Willowbank School Transport Assessment

Ministry of Education

WILLOWBANK SCHOOL - ABLEY RESPONSE TO AUCKLAND COUNCIL AND AUCKLAND TRANSPORT FEEDBACK ON DRAFT ITA REPORT – DECEMBER 2021

Figure 3.1 Extent of school traffic parking in mornings

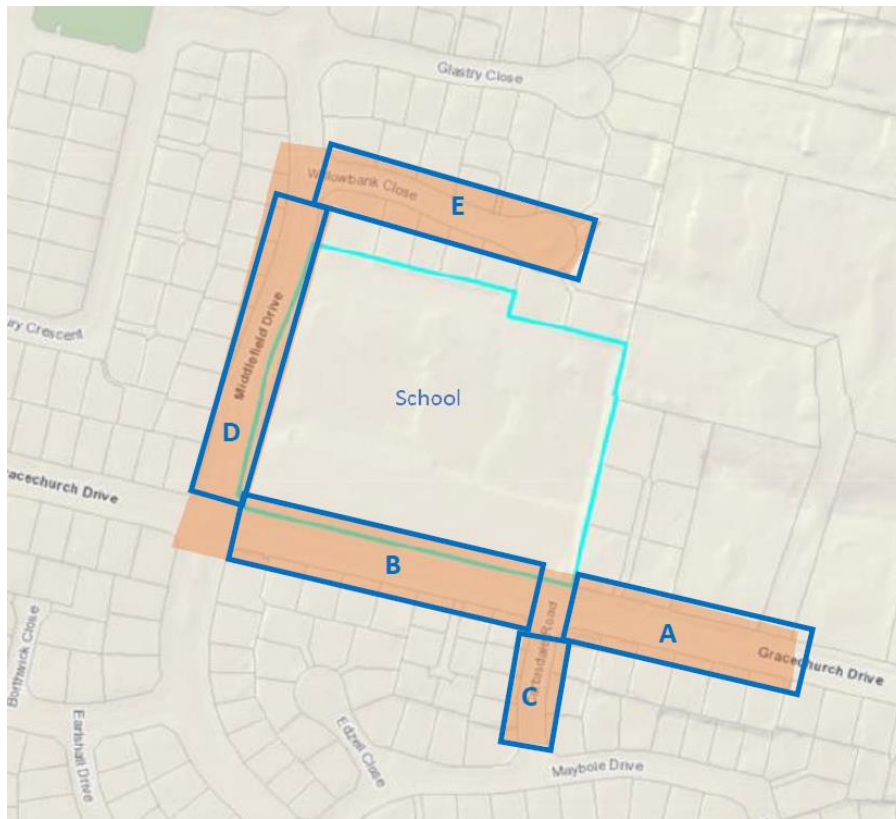
3. Please provide a map showing the physical extents of the survey areas A to J noted in the appendix to the TA.	Figures 3.1 and 3.2 are updated with parking zones labelled A to J.
